HOMOLOGATION AND TECHNICAL SPECIFICATION UPDATE BULLETIN

HOMOLOGATION	PRD GALAXY	HOMOLOGATION NO.	100H
BULLETIN NO.	100H-1	BULLETIN DATE	27 May 2016
SUBJECT	PRD GALAXY EXHAUST SYSTEM UPDATE

PRD GALAXY EXHAUST SYSTEM

DRAWING OF ORIGINAL EXHAUST SYSTEM

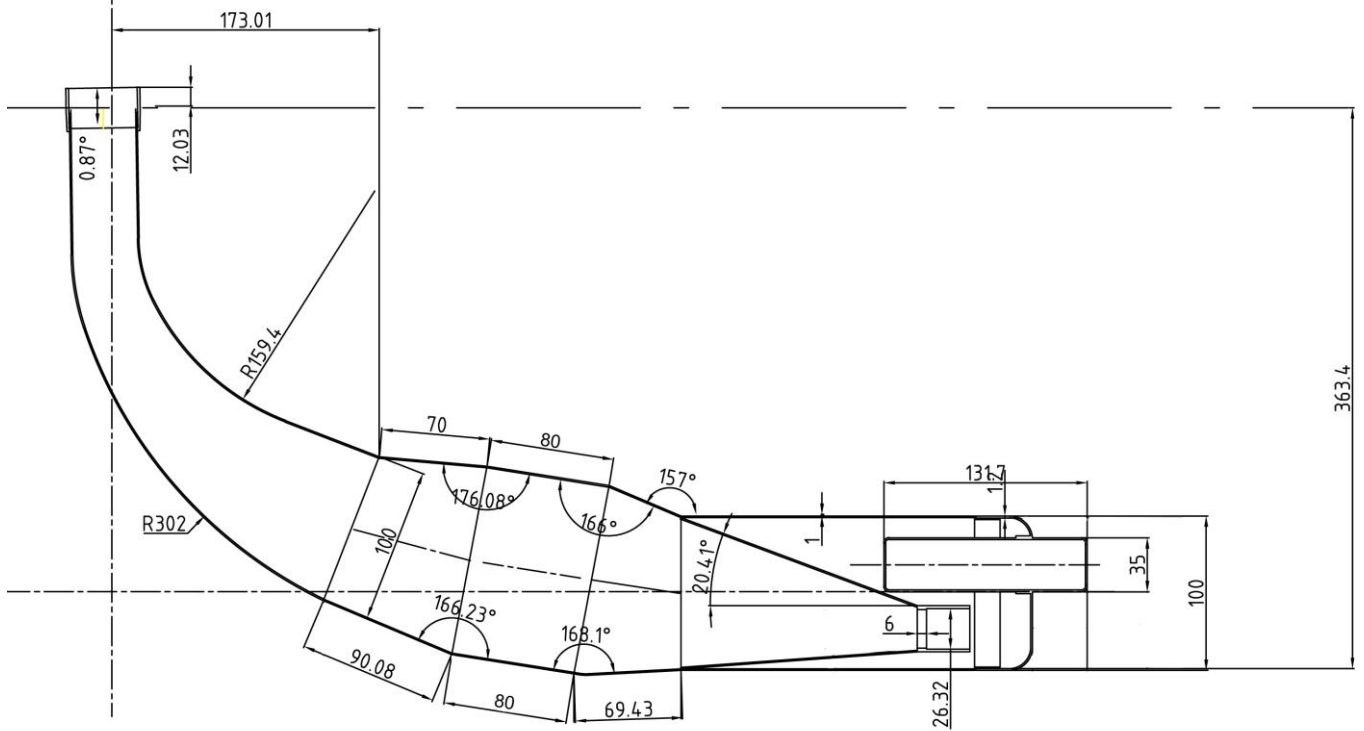
The replacement exhaust system is shorter. Competitors can compensate for the shorter exhaust system by using exhaust spacers (Part# PRD0019A) as homologated in document 100H.

Both exhaust systems are permitted to be used.
